**ADDENDUM NO. 3**

April 19, 2016

Plans & Specifications for: **Gilmore Playground, Waltham, MA**

This Addendum No. 3 is to modify, correct and/or supplement the Plans and Specifications.

DWG No. **L.1**

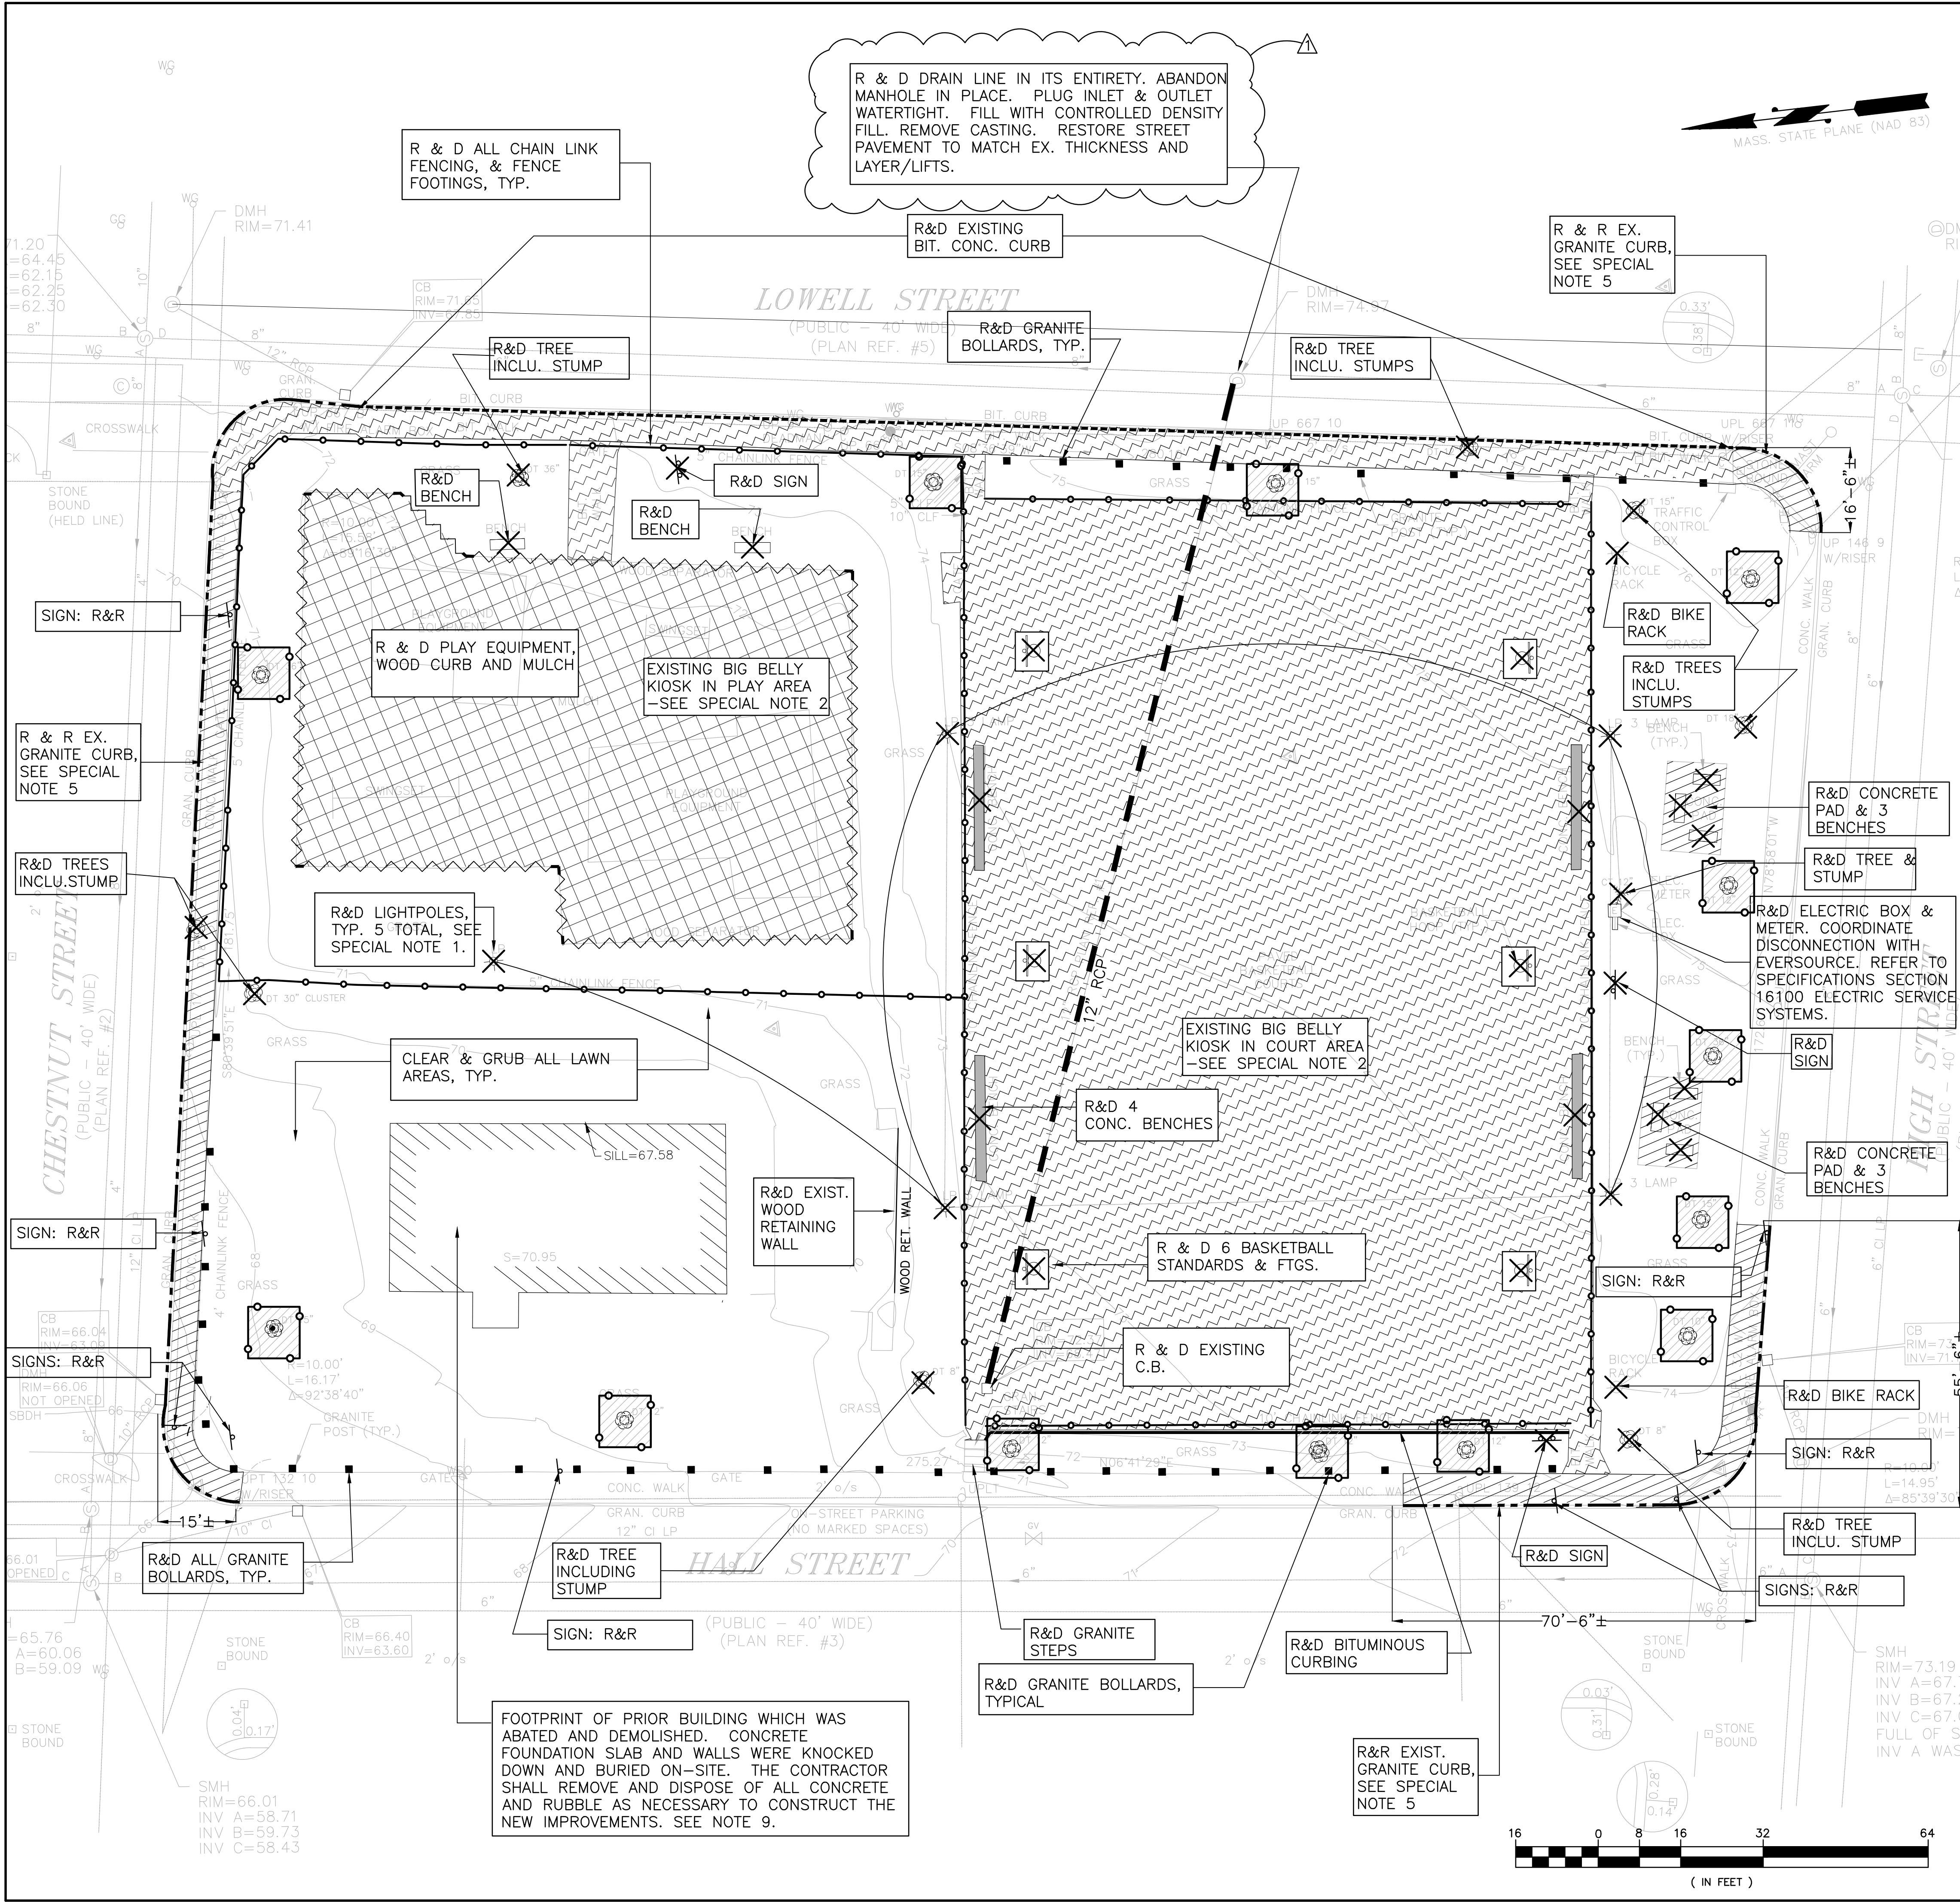
**ITEM NO. 4 Revision to Drawing L.1: Add abandonment of manhole**

No.	Description	Date
1	ABANDON EX. MH PER ADDENDUM #3	04/18/16

R & D DRAIN LINE IN ITS ENTIRETY. ABANDON MANHOLE IN PLACE. PLUG INLET & OUTLET WATERTIGHT. FILL WITH CONTROLLED DENSITY FILL. REMOVE CASTING. RESTORE STREET PAVEMENT TO MATCH EX. THICKNESS AND LAYER/LIFTS.

DWG No. **L.4**

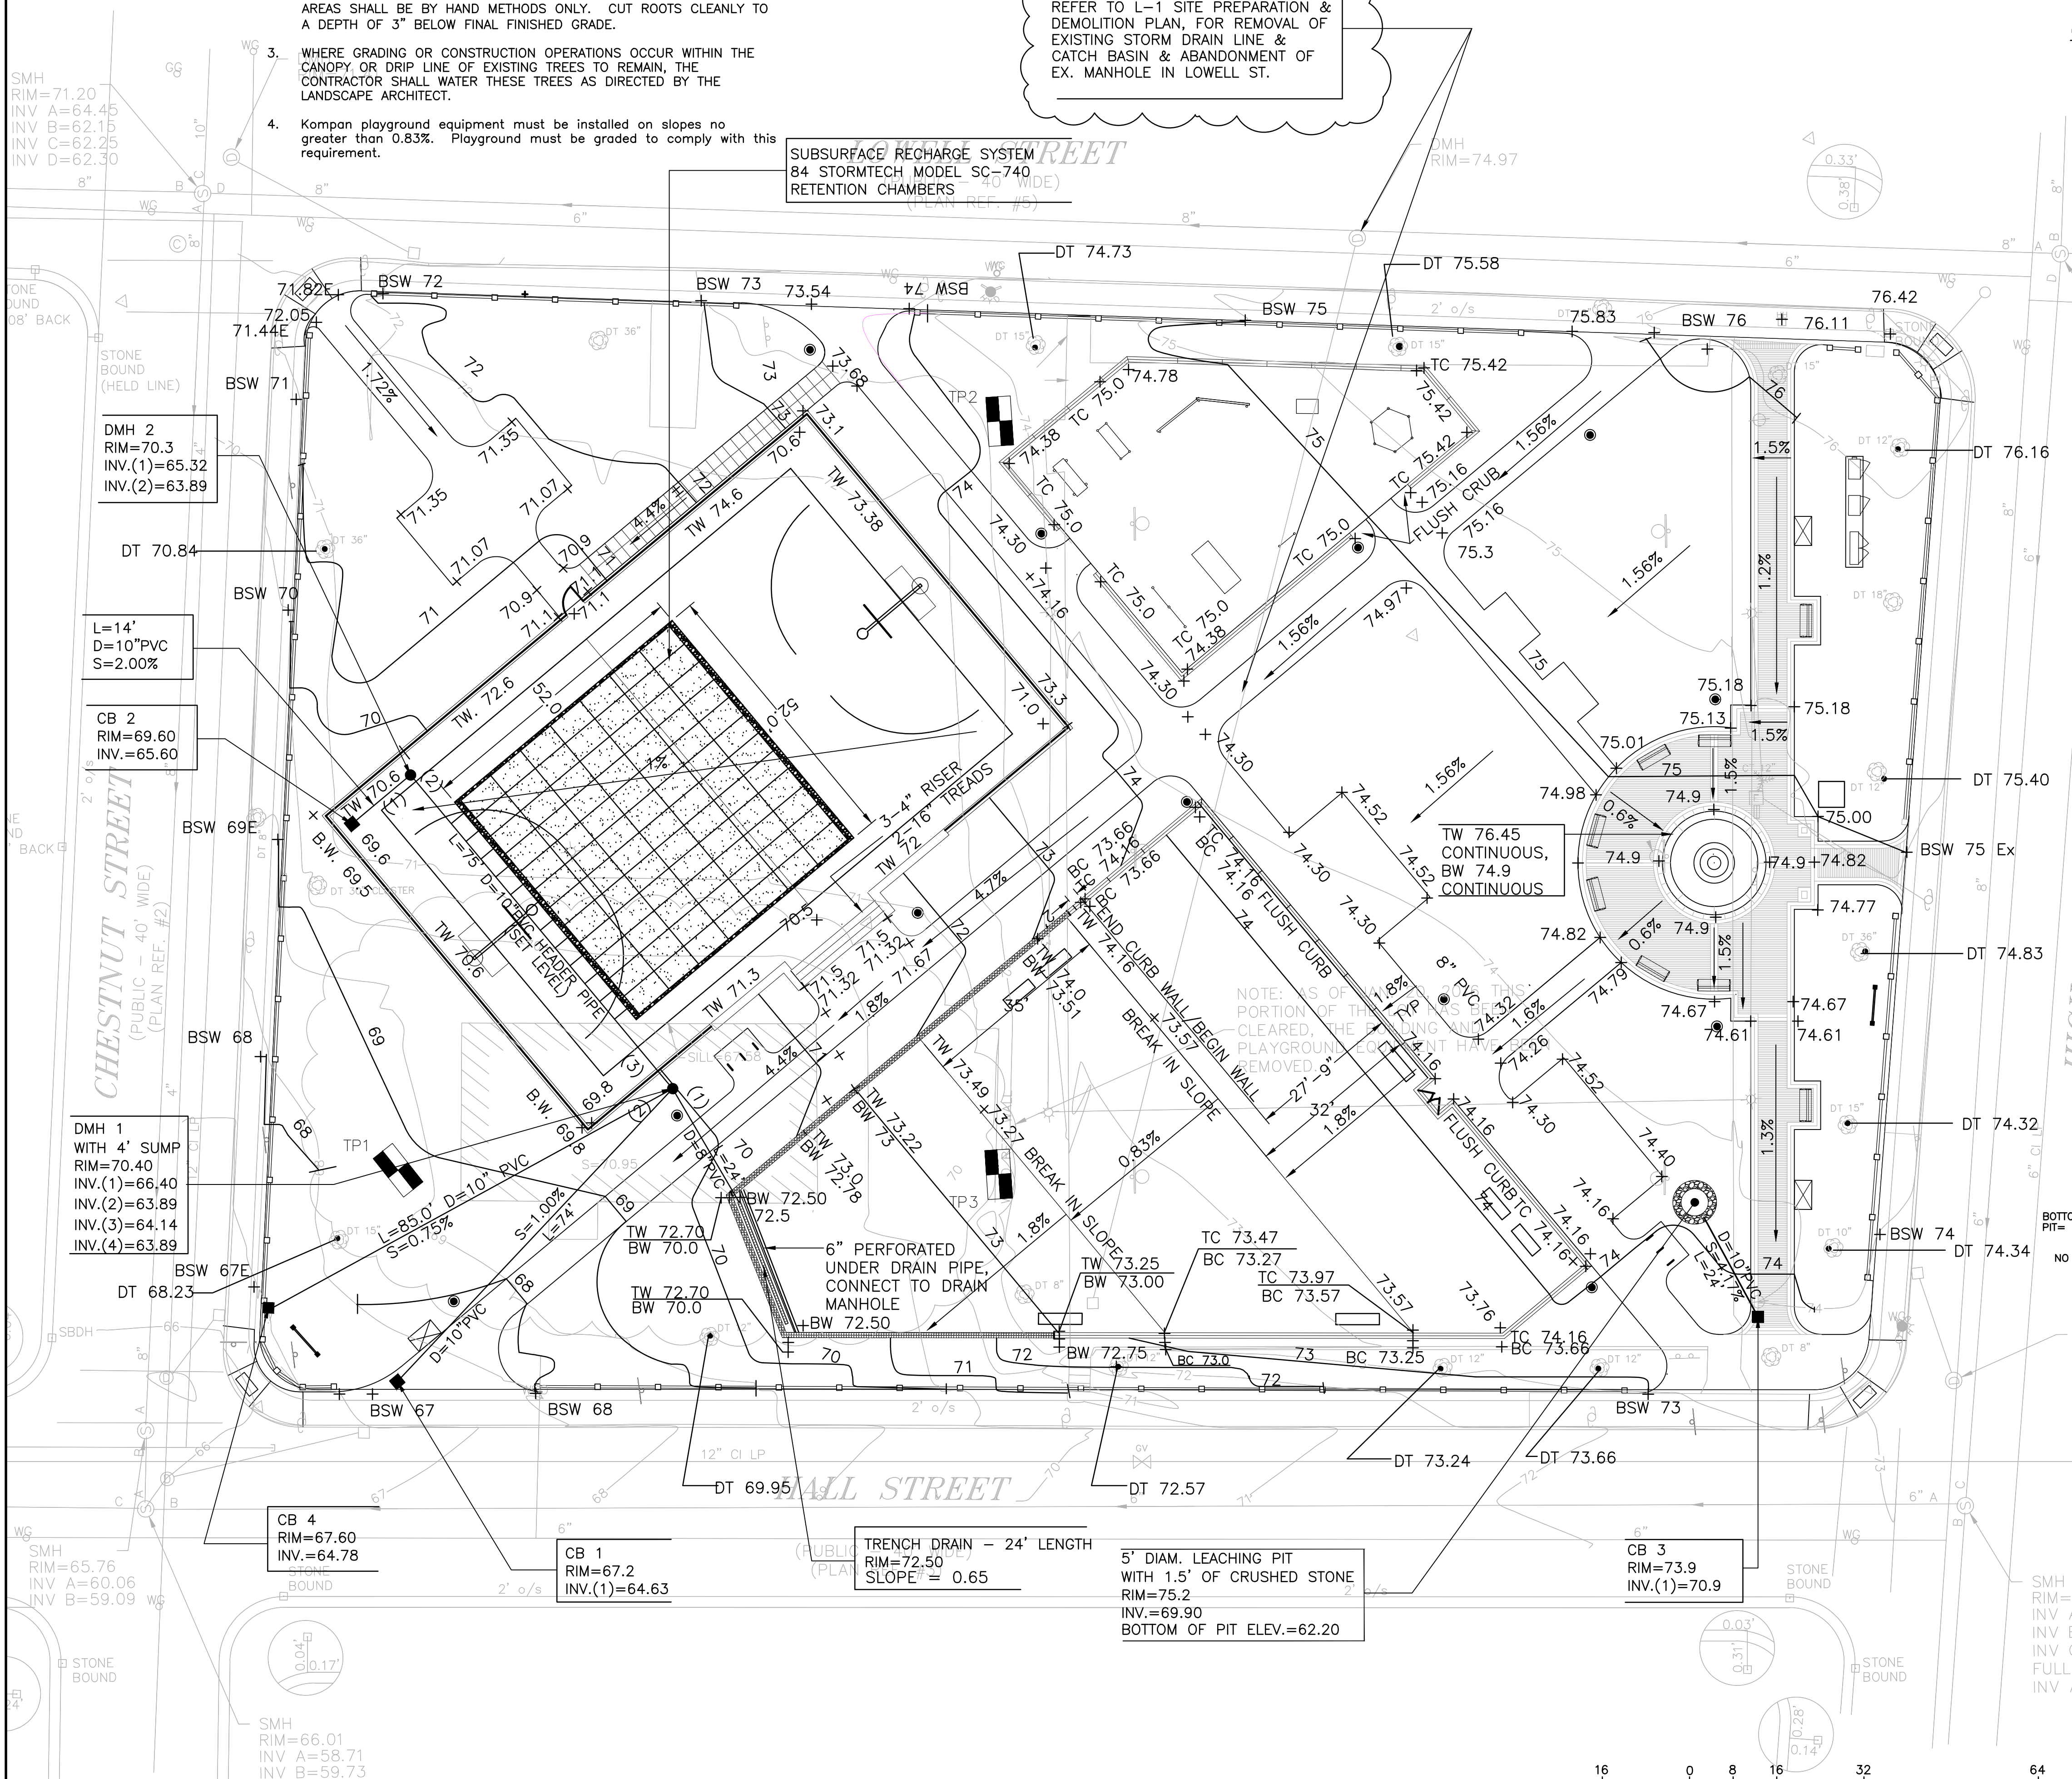
**ITEM NO. 5 Revision to Drawing L-4: Add abandonment of manhole**

No.	Description	Date
1	ABANDON EX. MH PER ADDENDUM #3	04/18/16

REFER TO L-1 SITE PREPARATION & DEMOLITION PLAN, FOR REMOVAL OF EXISTING STORM DRAIN LINE & CATCH BASIN & ABANDONMENT OF EX. MANHOLE IN LOWELL ST.
